ZONING BOARD OF APPEALS MEETING

LOCATION: TOWNSHIP ANNEX, 7527 HIGHLAND ROAD, WHITE LAKE, MICHIGAN 48383
THURSDAY, MAY 23, 2024 – 6:30 PM

**WHITE LAKE TOWNSHIP
ZONING BOARD OF APPEALS
APRIL 25, 2024**

PARCEL 12-13-157-006

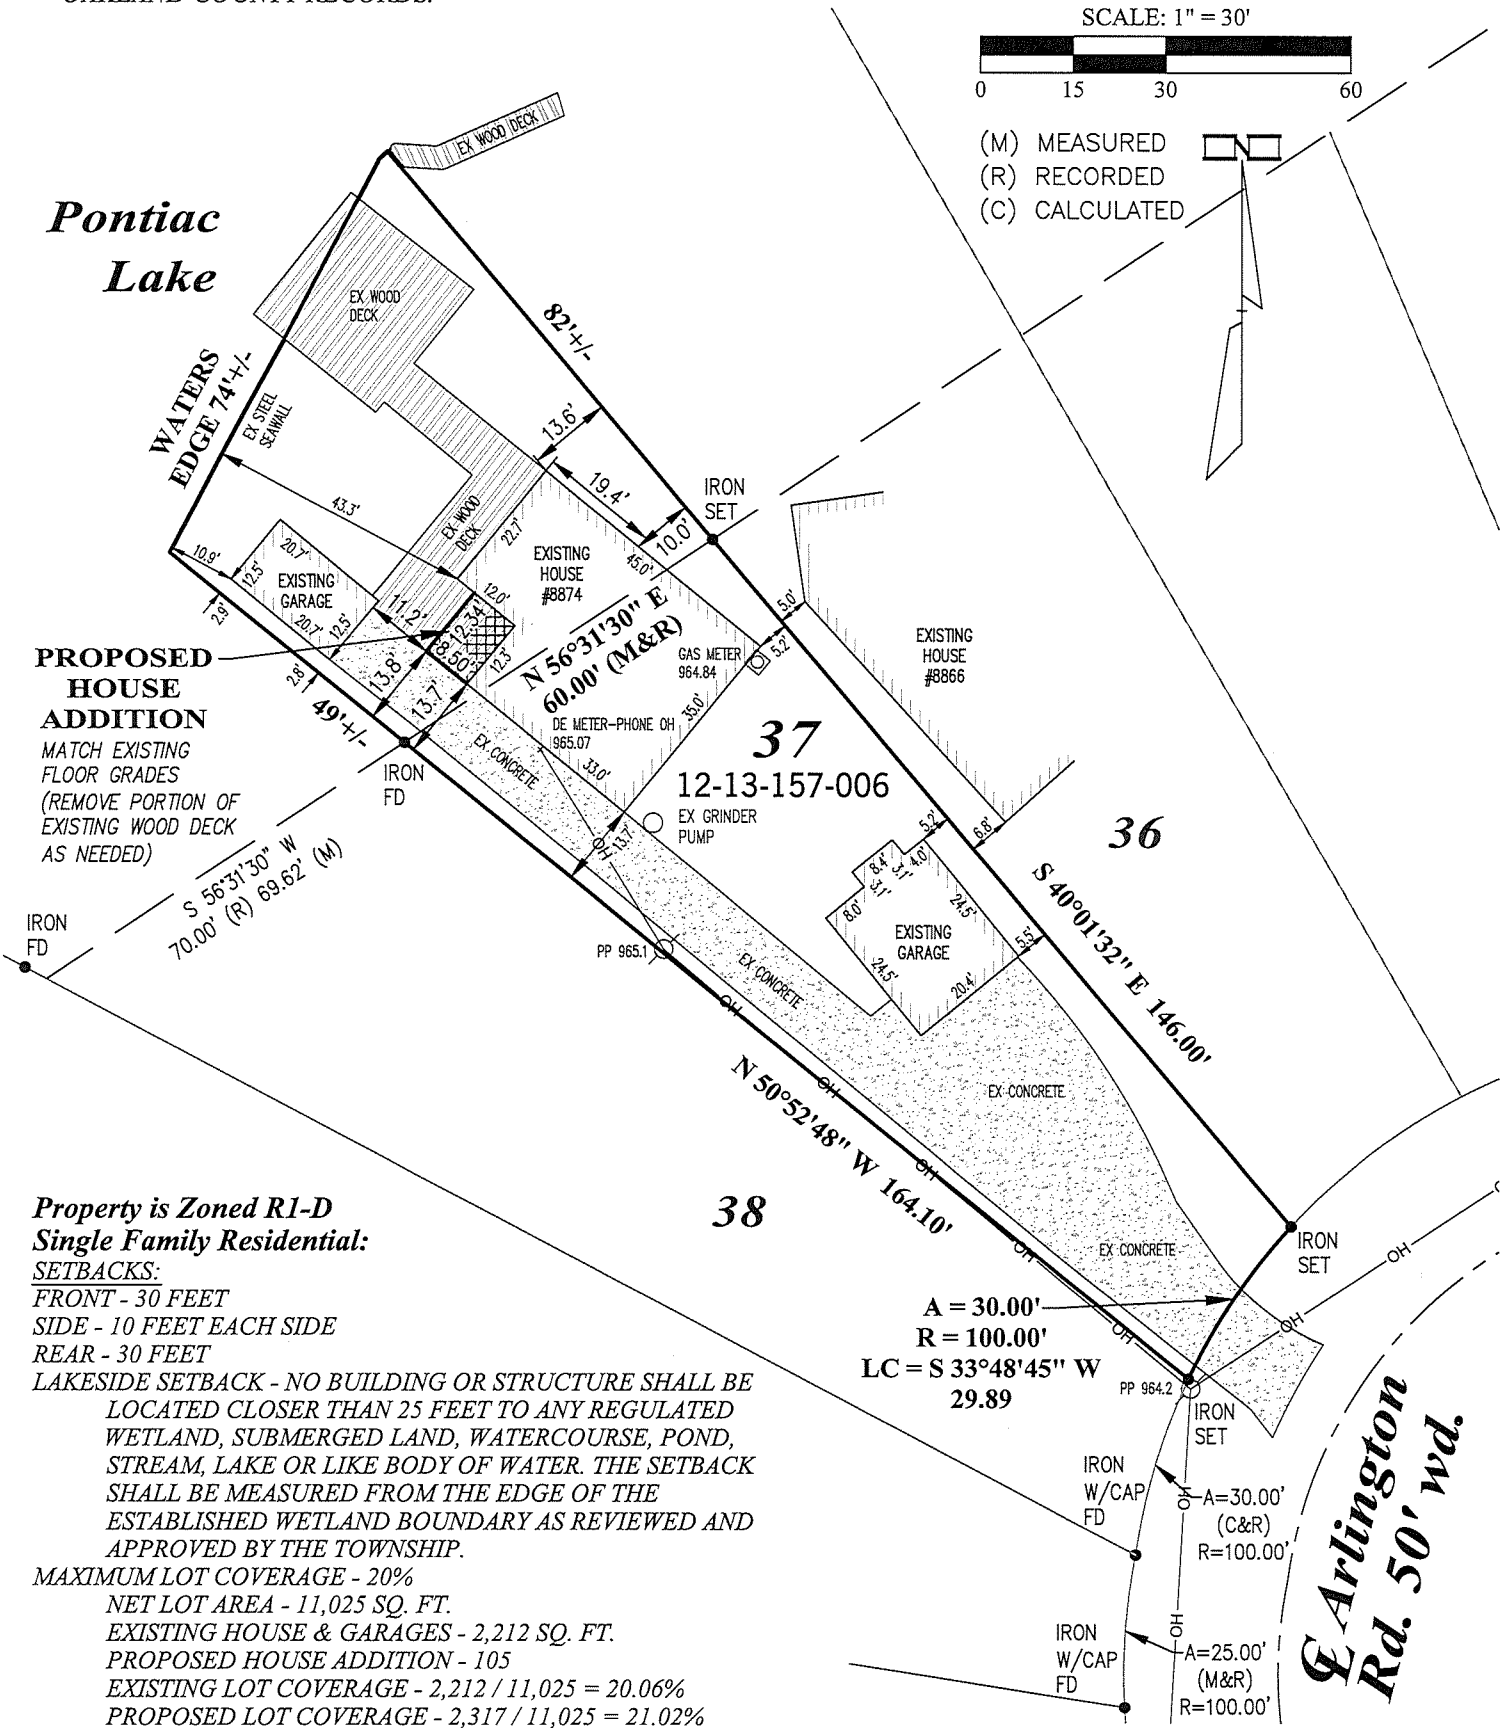
Member Schillack asked Staff Planner Quagliata if the property was serviced by well and septic. Staff Planner Quagliata confirmed. Member Schillack stated the well and septic did not appear to be on the survey.

Member Schillack stated there was clarification needed since there was a missing dimension on the survey of the southwest corner of the house to the side lot line. He added the ZBA needed all of the data to make accurate decisions.

- **The Applicant shall obtain all necessary permits from the White Lake Township Building Division.**
- **Prior to issuance of a building permit, a determination from the Building Official will be made as to whether a revised survey shall be submitted to dimension the setback from the southwest corner of the house to the west side lot line. The side yard setback from the west lot line must be at least five feet.**
- **The addition's roof overhang shall be no closer than five feet to the west side lot line.**

DESIGNED BY: AEB
DRAWN BY: RR/CZ
CHECKED BY:
SCALE: 1" = 40'
JOB NO: 22-029-1
DATE: 01/05/23
SHEET NO: 3

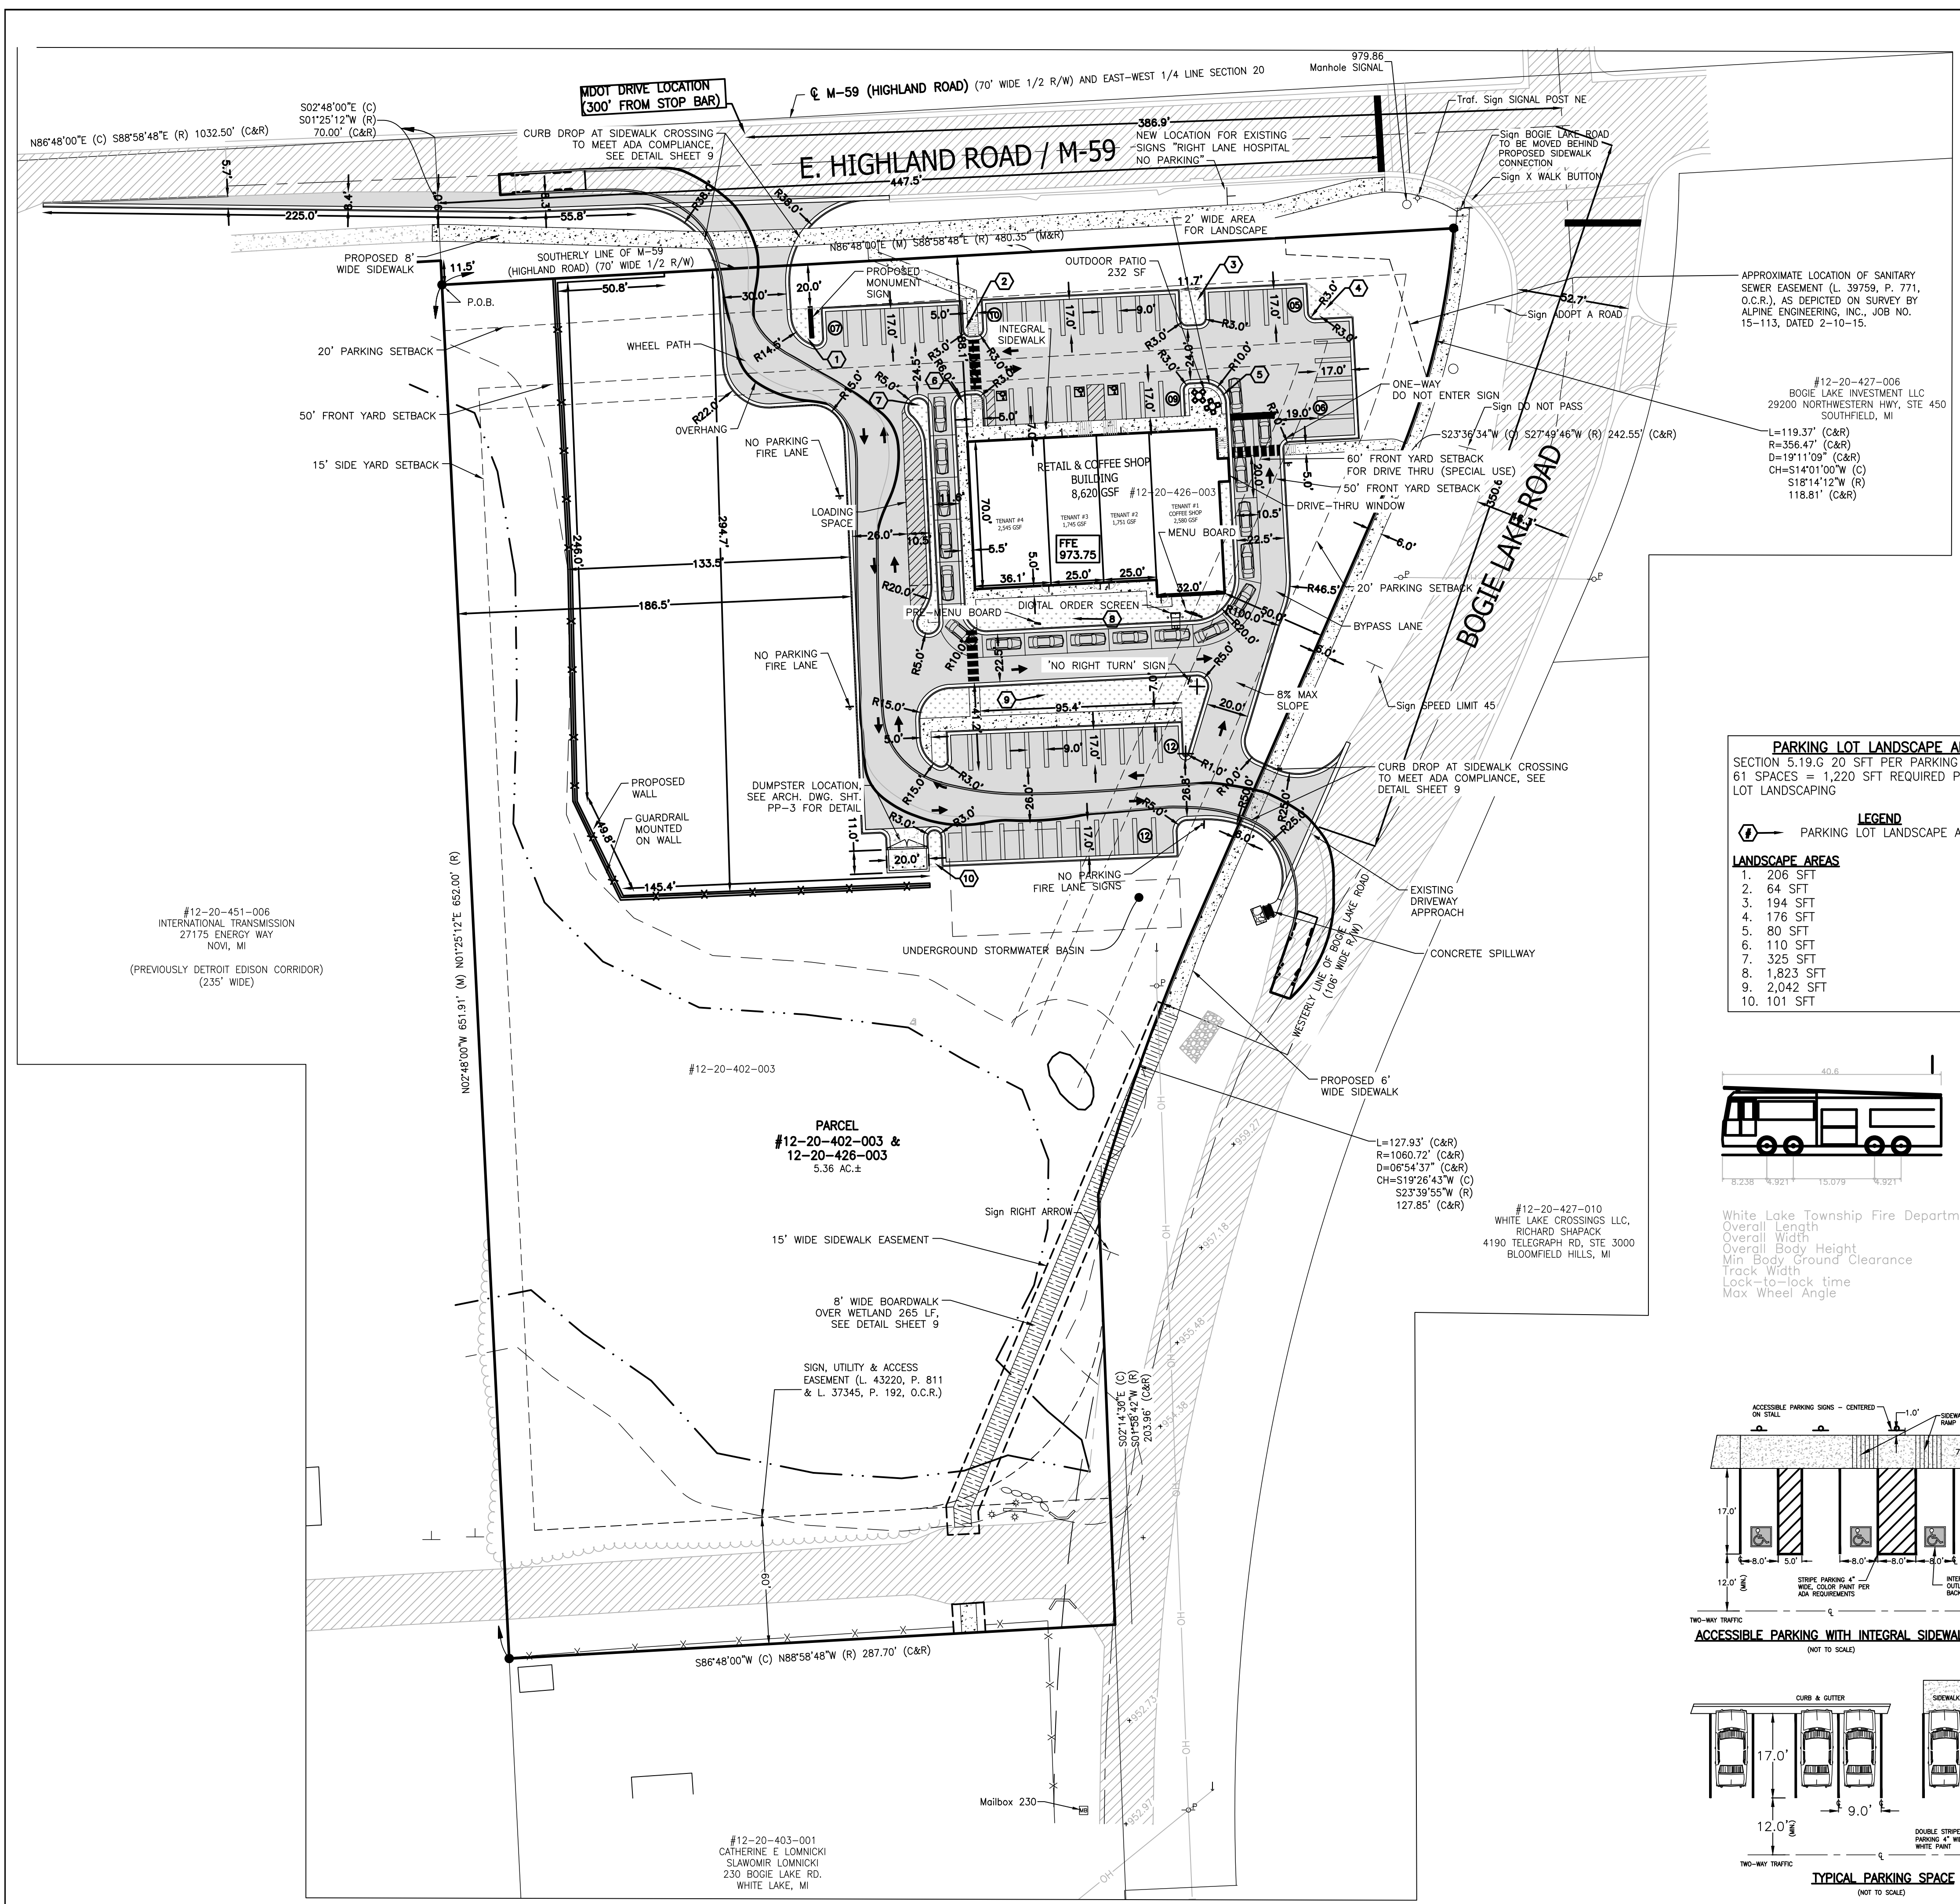
The development standards for the GB district require 50-foot front yard setbacks, 20-foot rear yard setbacks, and 15-foot side yard setbacks. **The proposed front (east) setback listed in the Site Data table on Sheet 3 is incorrect. Revise accordingly. (Comment addressed. The proposed east setback in the Site Data Table is now shown correctly). General Note 2 on Sheet 7 identifies the west setback as a front yard and not a side yard. Revise accordingly. (Comment addressed. The note has been revised).** The maximum building height allowed is 35 feet or two stories, whichever is less. Article 4, Section 17 of the zoning ordinance provides additional standards for drive-in or drive-thru window service, including a front yard setback of 60 feet (see Page 8 of this report regarding this requirement).

The parking calculations in the Site Data table on Sheet 3 are incorrect and shall be revised. (Comment outstanding. When units or measurements determining number of required parking spaces result in fractional space, any fraction up to and including one-half shall be disregarded and fractions over one-half shall require one parking space). (Comment addressed. Required parking calculations have been updated. See following comments). ~~54 parking spaces are required for Culver's, not 46. 31 parking spaces are required for the coffee shop, not 19.~~ The fast food standard shall be applied to the coffee shop. (Comment outstanding. Revise accordingly). (Comment addressed. Required parking calculations have been updated. See following comments). ~~Retail tenant space #1 requires 13 12 parking spaces, not 11 13. Retail tenant spaces #2 and #3 each require nine parking spaces, not seven. Additionally, gross floor area is utilized for fast food and retail uses, not useable floor area. It is unacceptable to remove 15 percent of the floor area from the parking calculations.~~ (Comment addressed). ~~116 65-77 parking spaces and 8 stacking spaces are required to serve the development and 90 48-61 parking spaces and 16 stacking spaces are proposed; therefore, a 261716-parking space variance is required from the Zoning Board of Appeals.~~ (Revise parking variance note on Sheet 3 accordingly). (Comment addressed. The applicable note on Sheet 4 has been updated).

The zoning ordinance requires each individual parking space be delineated by dual stripes, two feet apart centered on the dividing lines and painted white. Revise the site plan and the typical parking space detail on Sheet 3. If the required striping is not provided, a variance is required from the Zoning Board of Appeals. (Comment addressed. The plans as well as the parking space detail on Sheet 3 (now Sheet 4) now show white dual striping).

~~Culver's and t~~The coffee shop would be required to adhere to said hours of operation. **(Revise Site Plan Note 3 on Sheet 3. The hours of operation pertain to the outdoor dining hours, not hours of operation for the coffee shop).** (Comment addressed. The note on Sheet 4 has been updated accordingly).
